New Reactors Division

Step 4 Assessment of Civil Engineering for the UK Advanced Boiling Water Reactor

Assessment Report: ONR-NR-AR-17-013
Revision 0
December 2017

Figure 8: Cross section through the T/B - C/B - R/B - Fv/B (North-South axis)

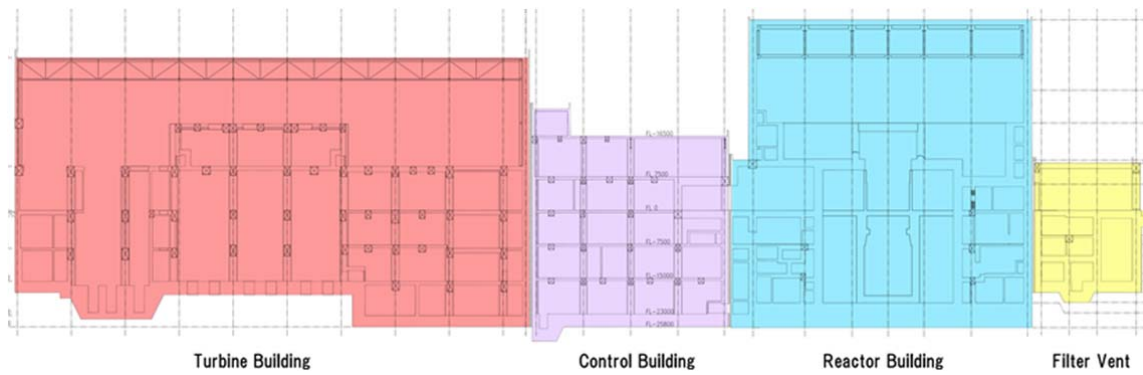
418. On assessing the design report for the C/B, I observed that the building was dependent on each of the surrounding buildings (the R/B and T/B north-south and the S/B and Rw/B east-west) to provide the necessary factor of safety against sliding. The RP's report proposed that the excess sliding force would be transferred via lean concrete at basemat level to be resisted by the adjacent basemats of the surrounding buildings.
419. I had a comment on this (Comment 01-CB14).
420. It was unclear whether the basemats are suitably aligned to allow the force to transfer. Conflicting information on the building embedment depths was present through a number of reports.
421. The RP has since confirmed that the basemats are aligned in the north-south axis (Figure 8) and that this remains the assumed load path.

- 422. In the east-west axis the basemats are not aligned. In recognition of this, the RP has revised the GDA design and introduced shear keys to the C/B to enhance the east-west sliding resistance sufficiently so that the building is self-stable. Two parallel shear keys are proposed (Figure 9) and the outline design and preliminary sizing of these was included in the submitted information.

Figure 9: Shear keys to the C/B (Extract from [S17-5] with colour added)

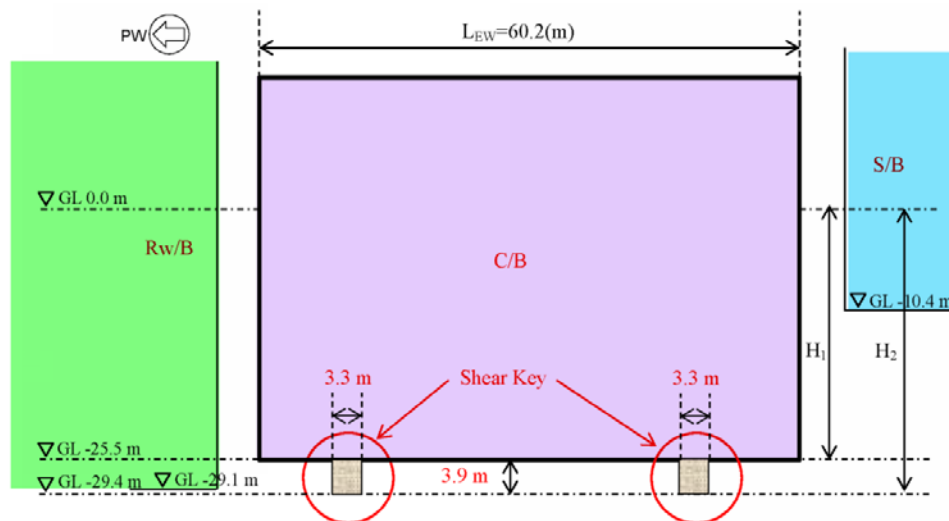
428. In response to Comment 01-CB14, the RP introduced shear keys to the S/B and the Rw/B to resist sliding in the east-west direction (Figure 10). The deferred section of comment 01-CB14 has been captured within assessment findings AF-ABWR-CE-02 and AF-ABWR-CE-08.

Figure 10: Shear keys to the Rw/B and S/B but omitting the key to the C/B

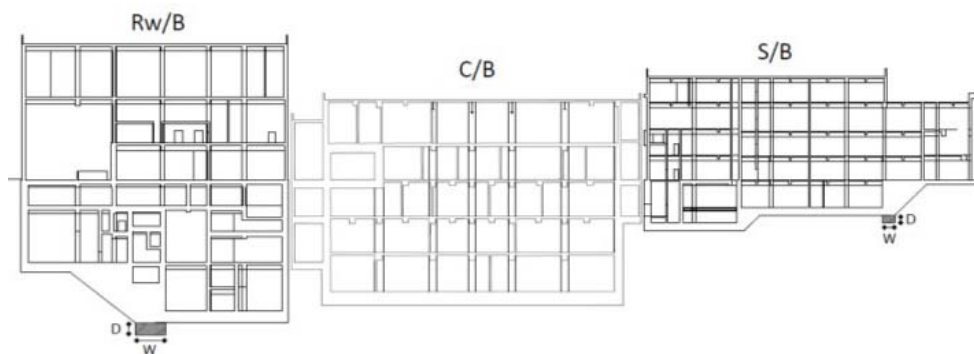
430. I have queried the performance and viability of the S/B shear key, noting that the formation of the S/B is significantly higher than that of the C/B. (Comment 01-RW12 part 4). There is a relatively small risk that the founding soil strata could have insufficient shear strength to prevent a shear plane forming below the shear key, which could surcharge the wall of the C/B. This should be checked at the site-specific stage. This comment has been captured in AF-ABWR-CE-08.

431. The shear keys are not shown on the formal general arrangement drawings and these elements are omitted from the various analysis models.
